ADDENDUM NUMBER

05

March 28, 2024

**PROJECT: MORGAN COUNTY EVENTS CENTER
ARCHITECT: GOODWYN MILLS CAWOOD
OWNER: MORGAN COUNTY COMMISSION**

G1.22

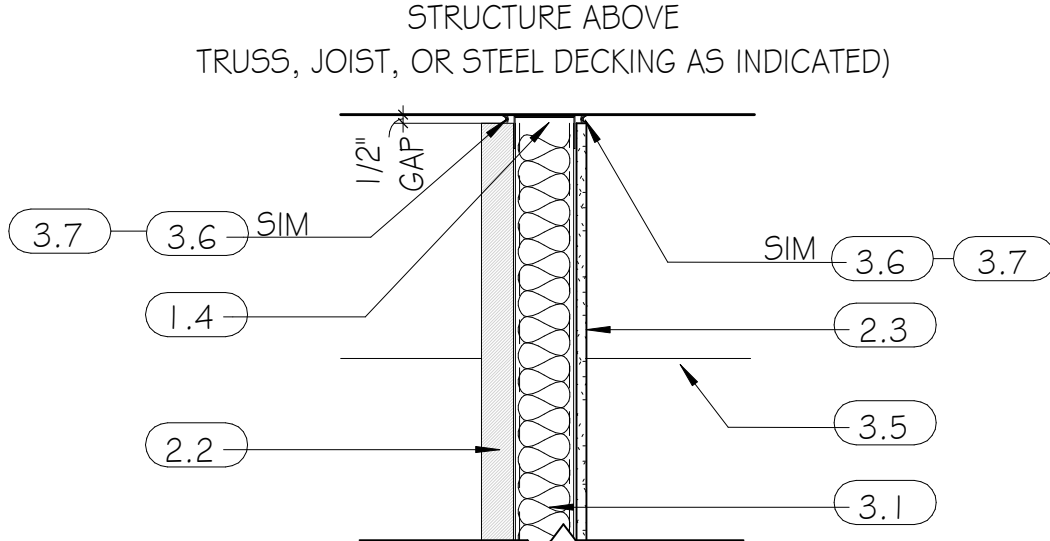
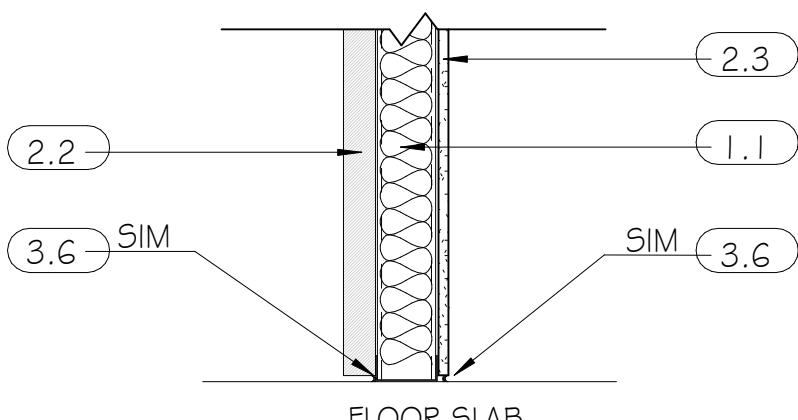
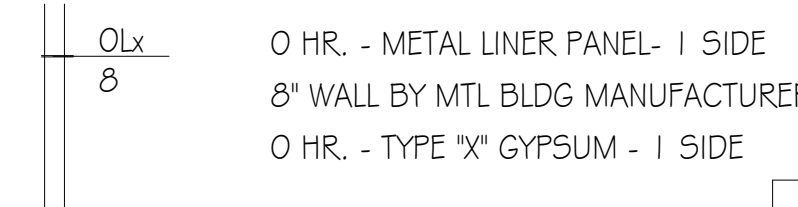
73			3/26/2024	Please confirm that there is no drywall at the interior side of the OL/12 wall, where there is 2" metal perforated panels in the Basketball & Volleyball courts (A&B).	Cooper Construction		Yes, correct. (As shown in OL 12, G1.22) Only in Kitchen, Multipurpose Rooms.	Addendum 5
74			3/26/2024	Are there any drywall on the interior side on the Multipurpose room Space #111 A & #112 B, on the OL/12 walls? Plans indicate that it is a 2" perforated prefinished metal panels. Please advise.	Cooper Construction		Perforated metal panel is only in the courts. Yes, drywall in Multipurposes rooms.	Addendum 5
75			3/26/2024	Spec book under the "Gypsum Assemblies" mention "Bullet Resistant boards," are we required to provide this type of boards and if so, can you help providing locations where this will occur?	Cooper Construction		No bullet-proof resistant boards in project.	Addendum 5
76			3/26/2024	Please provide spec section or basis of design for the metal shelving called out in the concession area on page A7.01	Dominguez Design-Build		Stainless wall shelving for Kitchen & Concessions to be equal to Uline steel wall shelf #H-7498, see attached. (double to meet required design lengths.)	Addendum 5

A1 FIRST FLOOR PLAN
SCALE: 1/8" = 1'-0"
TRUE NORTH

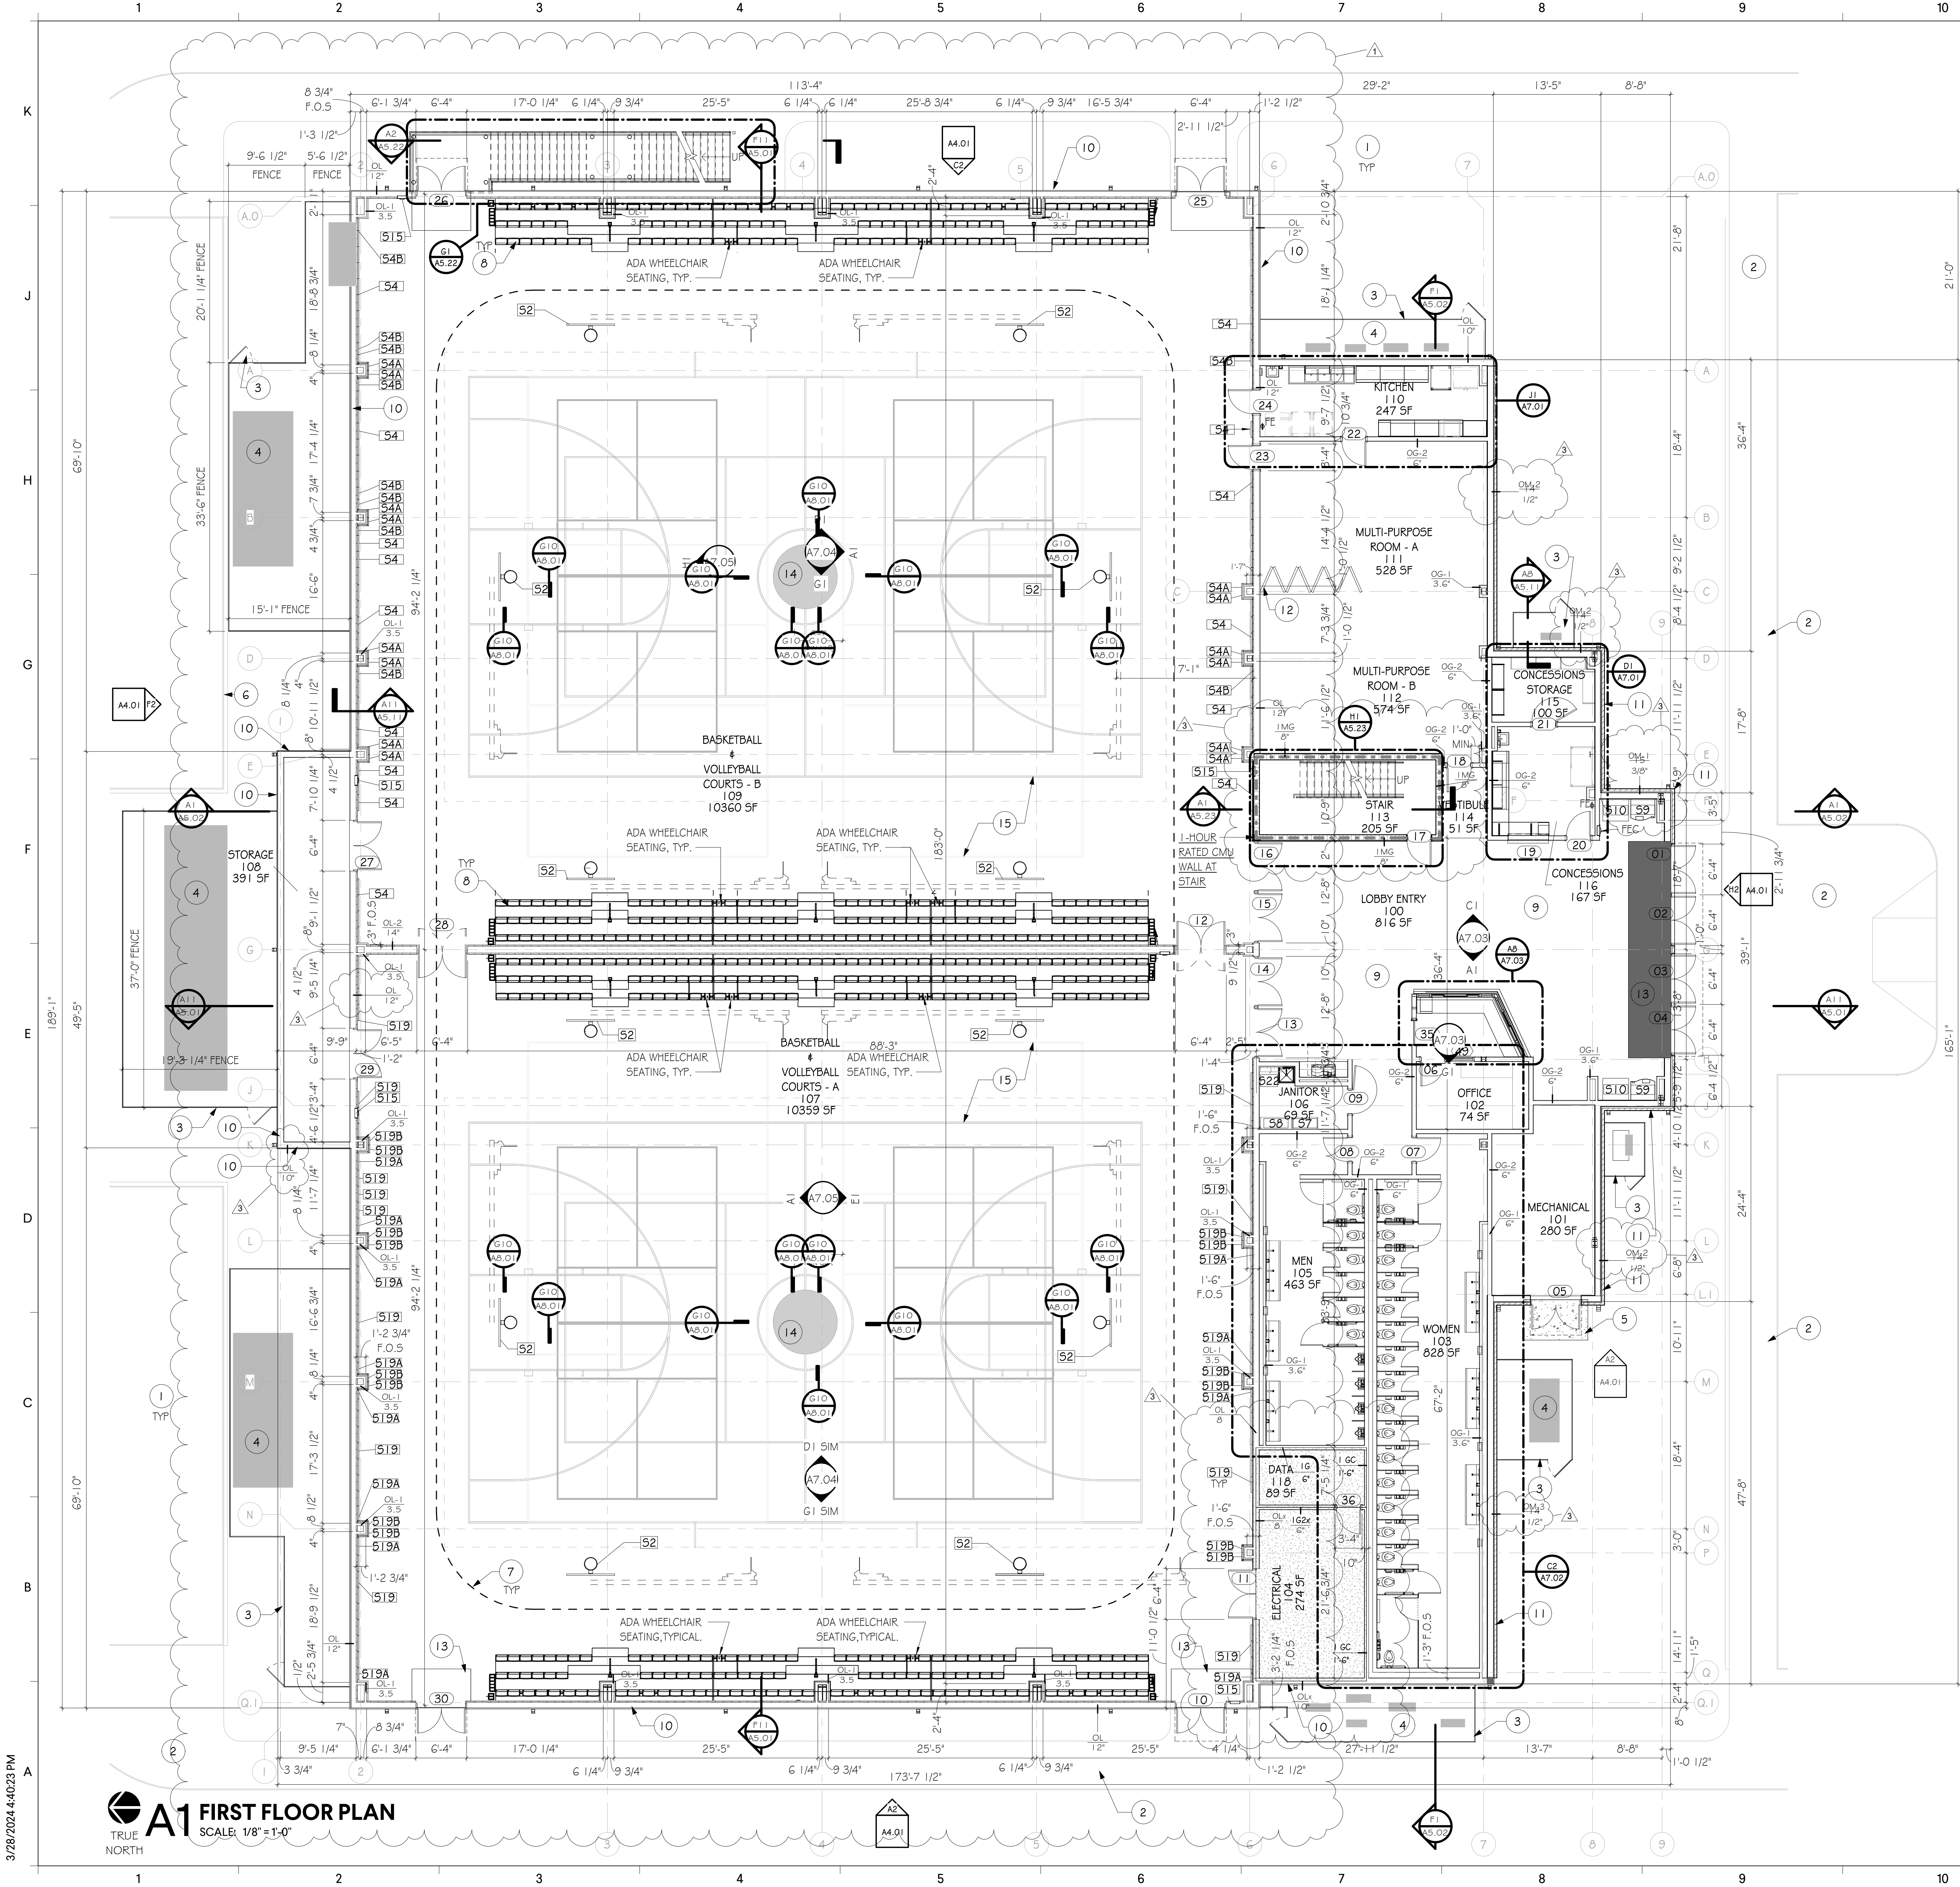
70			3/26/2024	There is a detail to provide metal framing and drywall at the underside of the scissor stairs on page A5.23, details H10, E10 & A10. Is the intention to frame the underside of the full stairs or just the underside of the intermediate landing and the top portion of the stair only?	Cooper Construction		Just as shown, at the landings (intermediate and top portion,) yes.	Addendum 5
71			3/26/2024	Keynotes – Floor Plan - #9 on page A1.01, calls for abuse boards in the Lobby. Am I to assume that all walls in 'Lobby Entry' space #100 will require abuse boards? If not, please specify the locations?	Cooper Construction		Yes, all walls in LOBBY ENTRY 100.	Addendum 5
72			3/26/2024	Are we to provide furring at the interior side of the stairwells as well? The IMG partition type shows furring on one side only; however, the CMU wall is tagged on both sides. Please advise how to proceed?	Cooper Construction		No, furring is only on the outside of the stairwell CMU. See revised A1.01 First Floor Plan.	Addendum 5

FIRST FLOOR PLAN FIRE PROTECTION

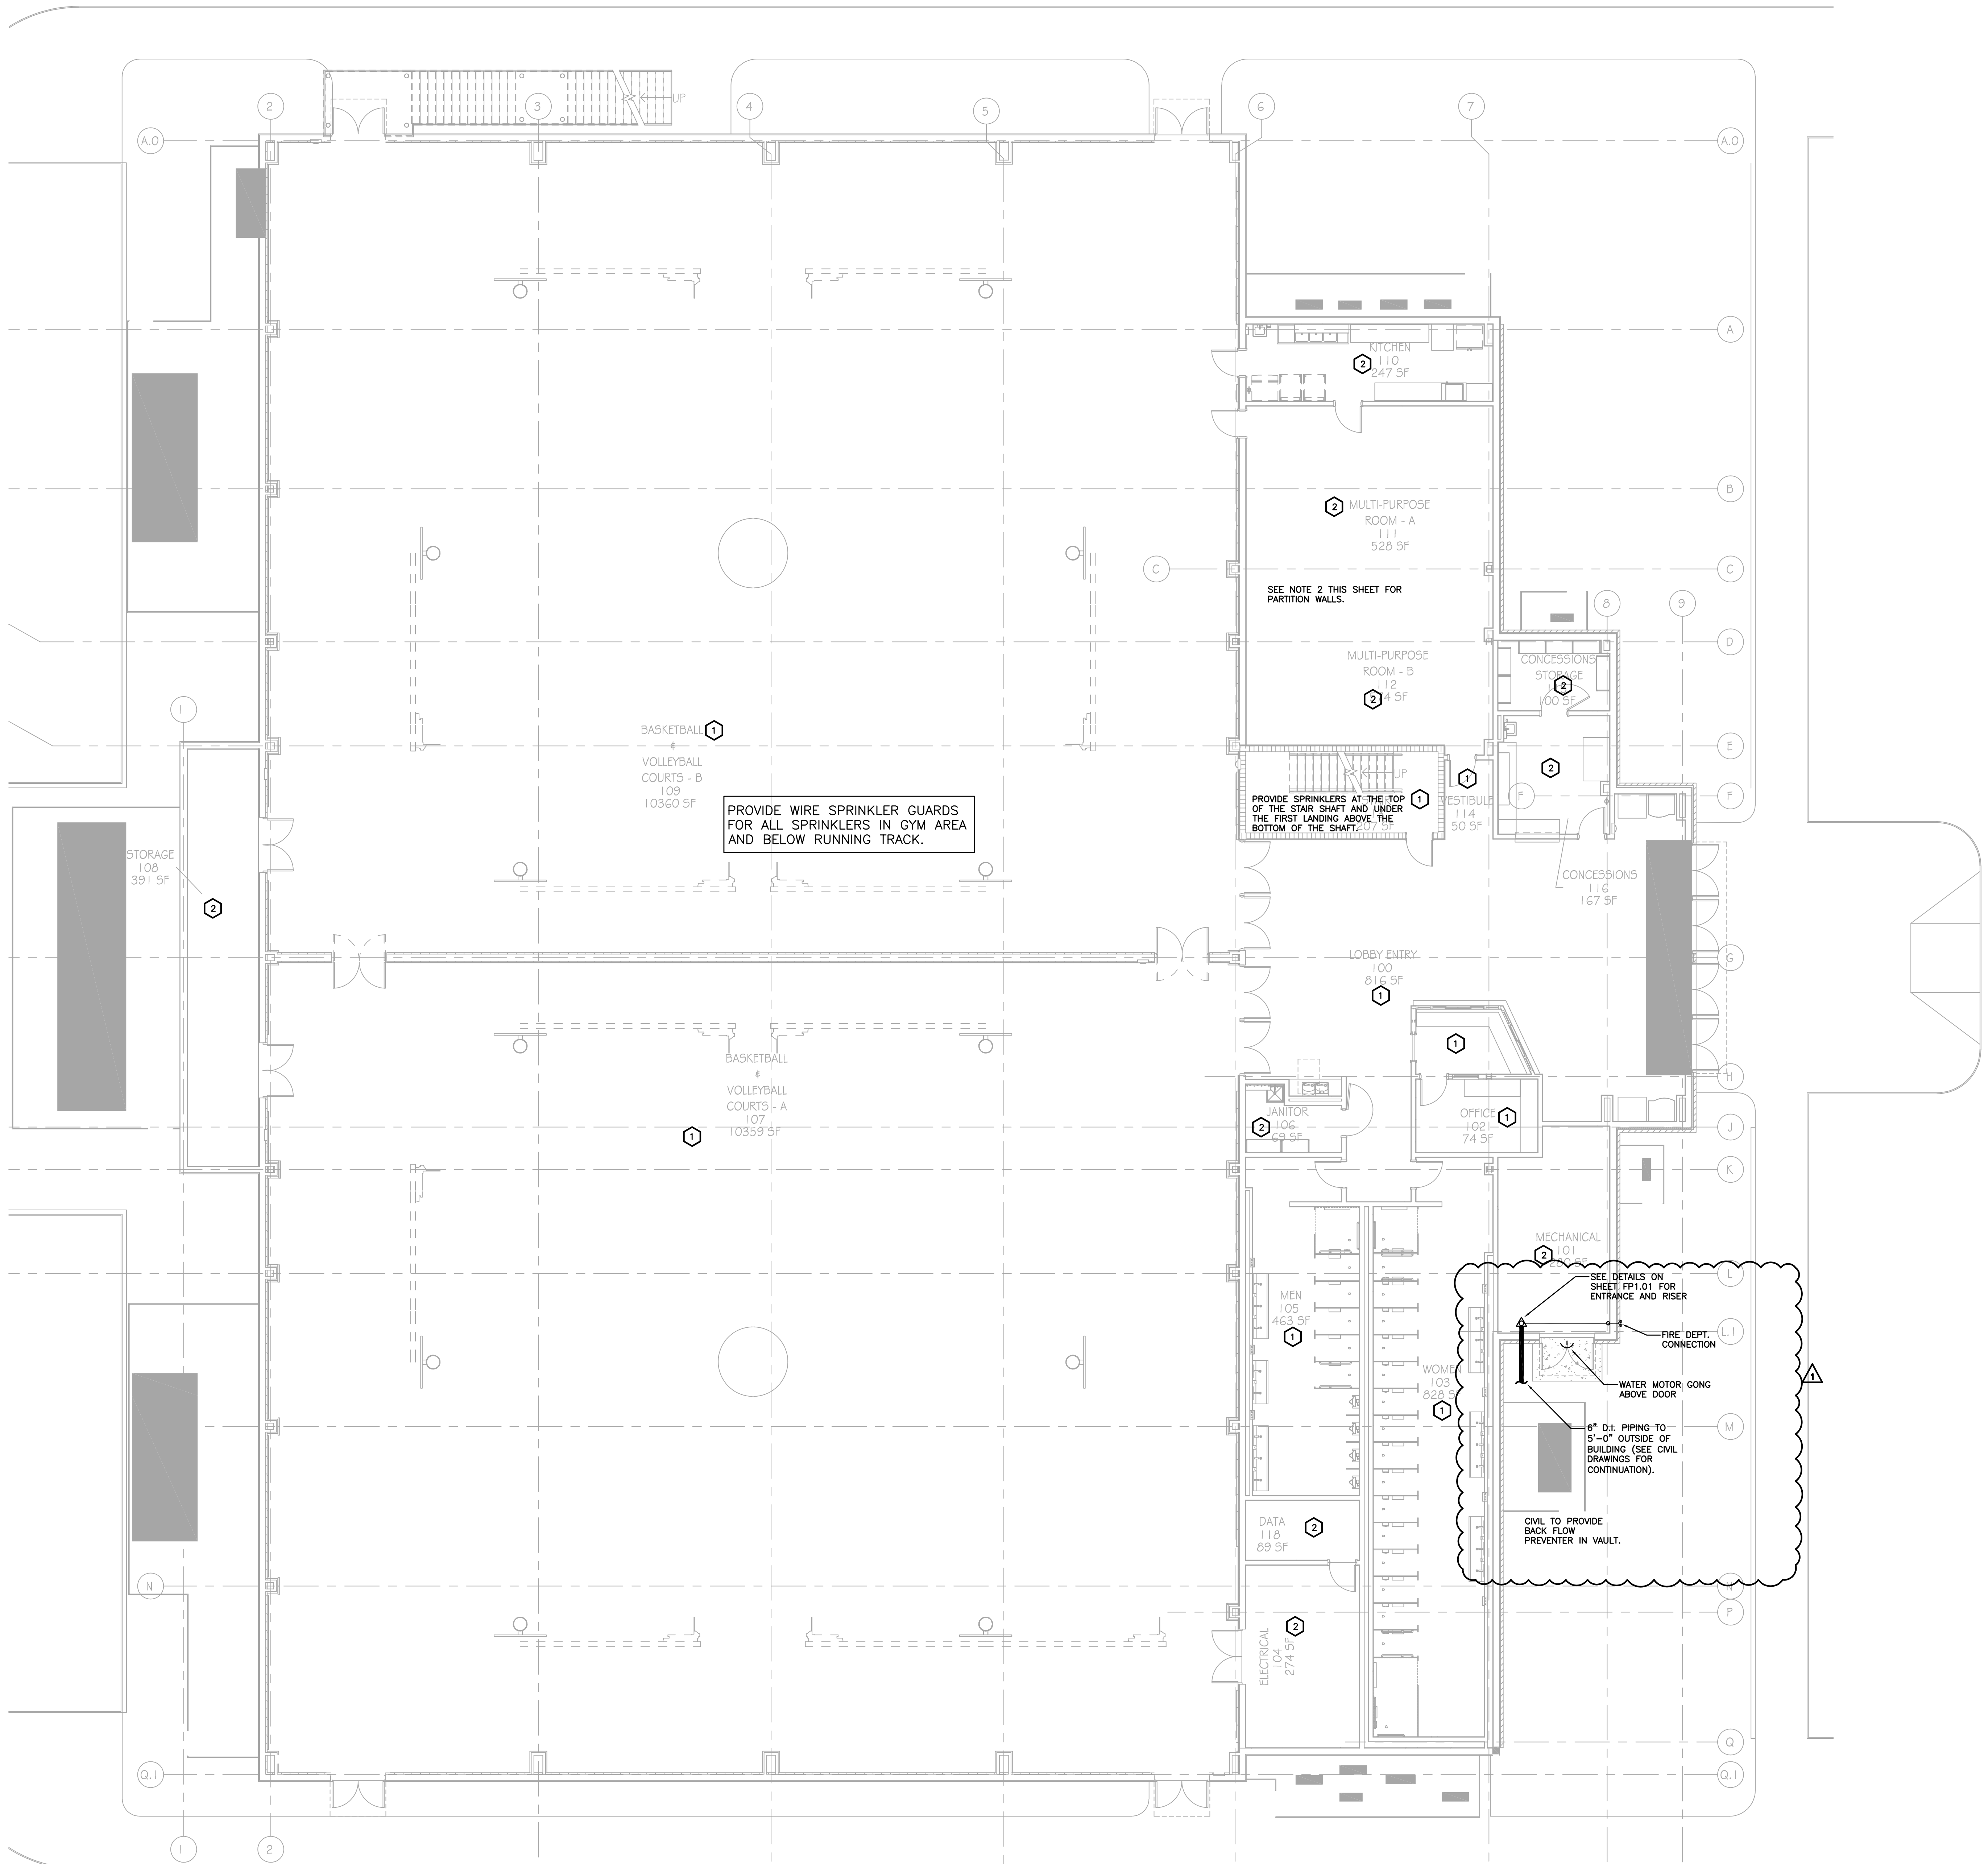
- H. Disregard FDC note on Sheet FP1.01 regarding FDC & backflow. Items will be provided by Utility & Owner at the street.
- I. Interior wall @ ELECTRICAL RM 104, DATA 118, and MECHANICAL 101 shall be 1 Hr. rated type “x” gypsum board, sealed @ deck.
